WATERLOO METRO QUARTER BUILDING 2

**SSD-10439 - RESPONSE TO SUBMISSIONS
SUPPLEMENTARY DESIGN REPORT**

This supplementary design report has been prepared to respond to Submission received for SSD-10439.

Alexandria Park Overshadowing

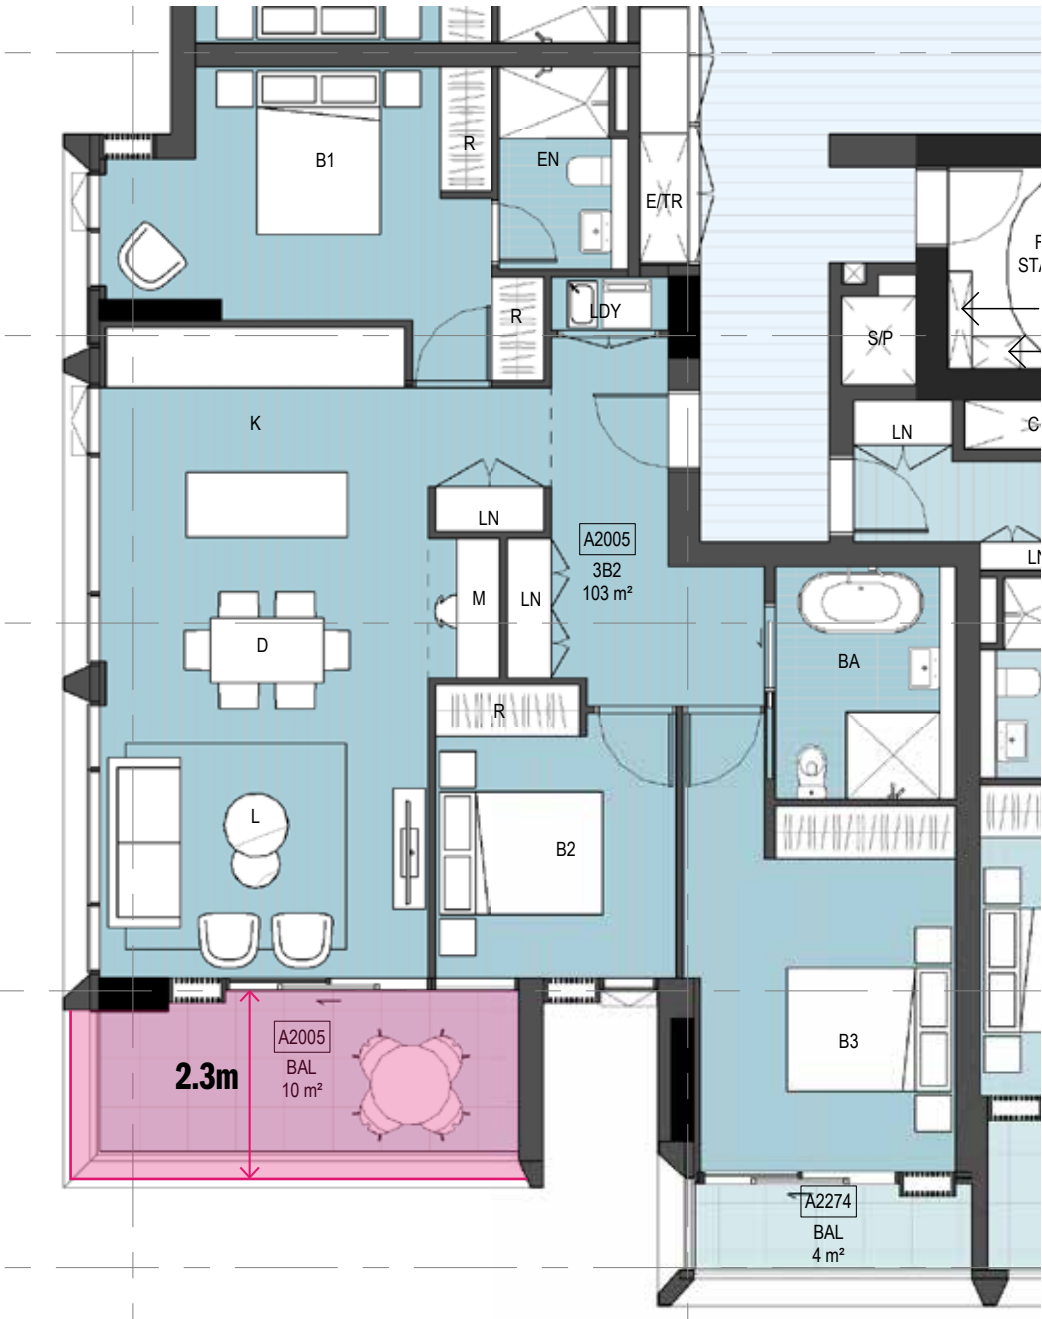
22. Private open space – 3-bedroom apartment balconies have less than the minimum 2.4m width (see apartment AXX05 on levels 20-21) as approximately 2 metres is provided. Insufficient room is provided to cater for furniture placement for the larger apartment and to allow space for other activities, contrary to Objective 4E-1 of the ADG.

- _Due to building envelope and massing constraint, without creating additional overshadowing to Alexandria Park, achieving the 2.4m depth will require pushing the glazing line into the apartment, severely compromising the internal layout and functionality.

_The massing of the building can not be adjusted to allow a deeper balcony without creating additional overshadowing to Alexandria Park.

- _Balcony baulstrade location and edge detail to be further explored in Design Development to provide a deeper balcony.
- _By pushing the balustrade towards the edge of balcony can potentially achieve a 2.3m deep balcony.

Alternative Botany Road Building 2 Interface Plan Diagram

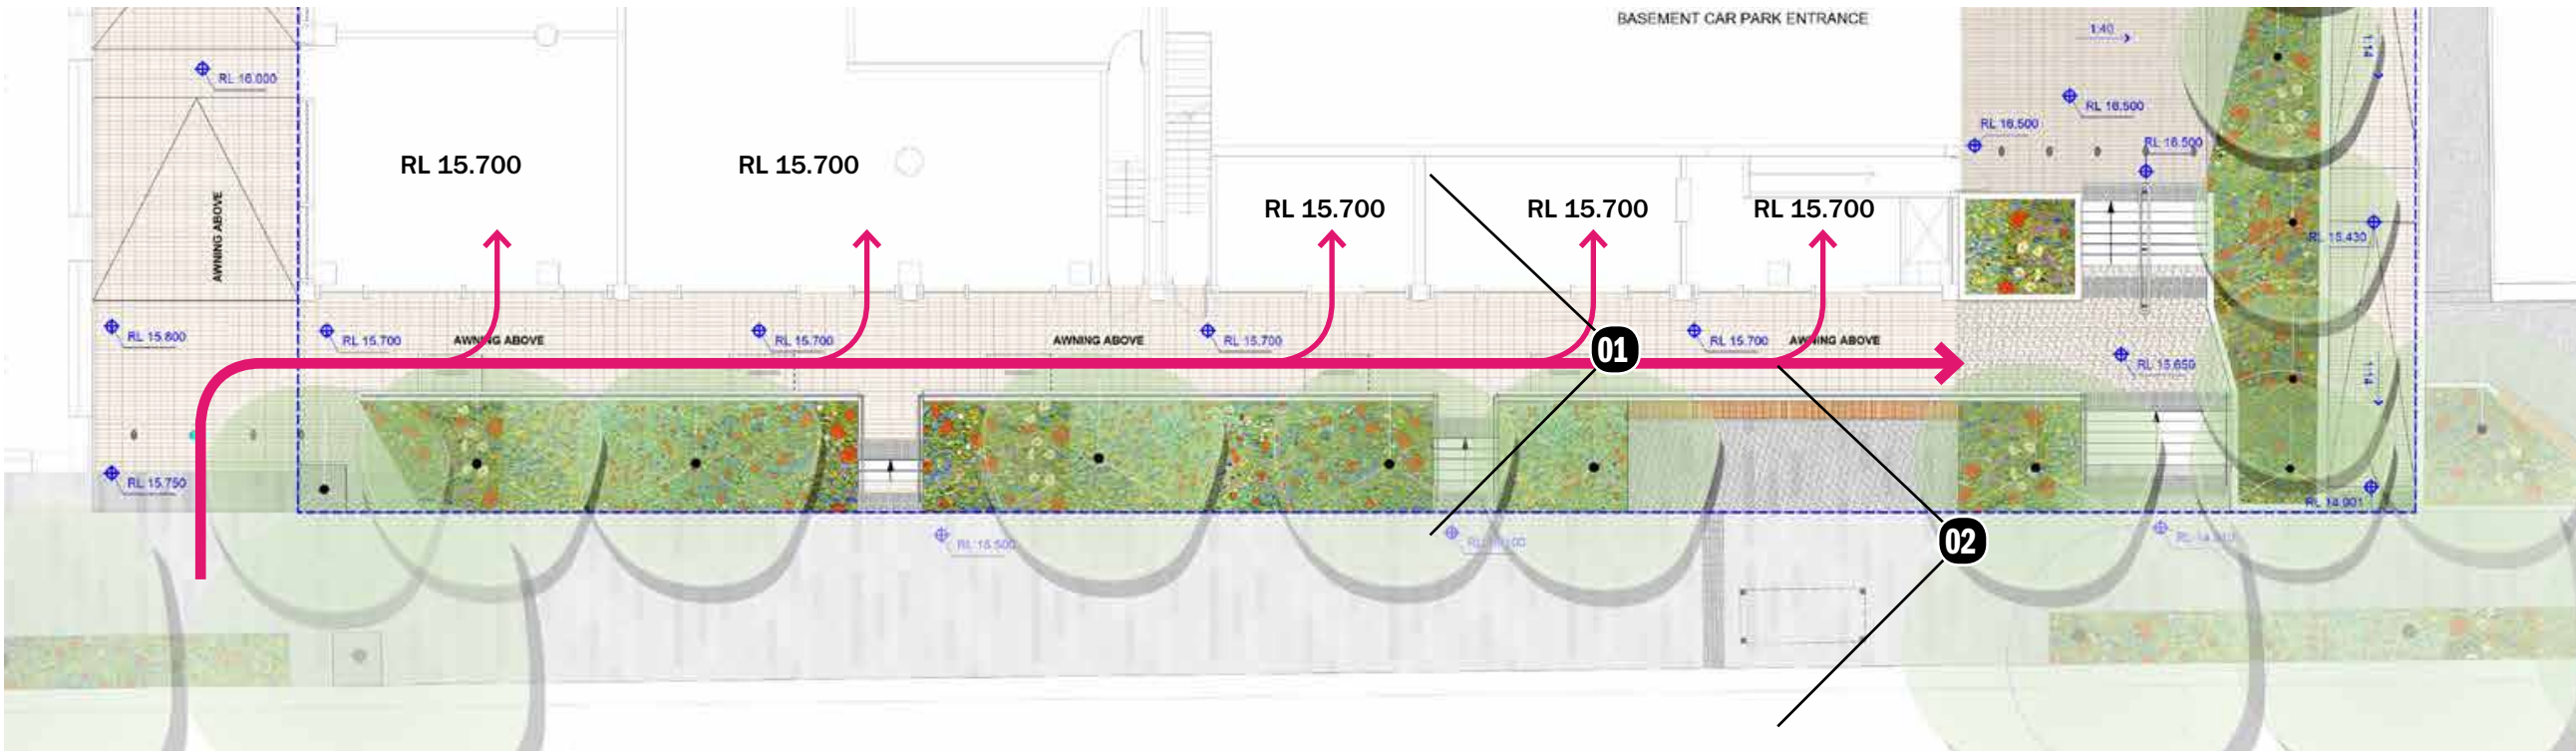
80. The reason given for the non-compliance is the relatively small areas of retail floor space available does not allow for adequate DDA compliant ramping form the surrounding Botany road public domain level. This reasoning is not supported and given this is a new development with no site constraints, compliance with the required flood planning levels should be achieved. The depth of flooding in the proposed retail space of up to 500mm during the 1% AEP storm is not acceptable. Further comments were provided by Environmental Energy and Science Group (EES).

- _To respond to the flooding constraint for Botany Road, an alternative design for Botany Road retail tenancies and adjacent footpath proposes to raise the retail tenancies along Botany Road in Building 2 to the flood planning level of 15.7m AHD. Stairs are proposed as a result of this.

- _The design complies with DDA requirement, providing equitable access into the Botany Road retail area from the northern end of building 2 adjacent to Grit Lane.
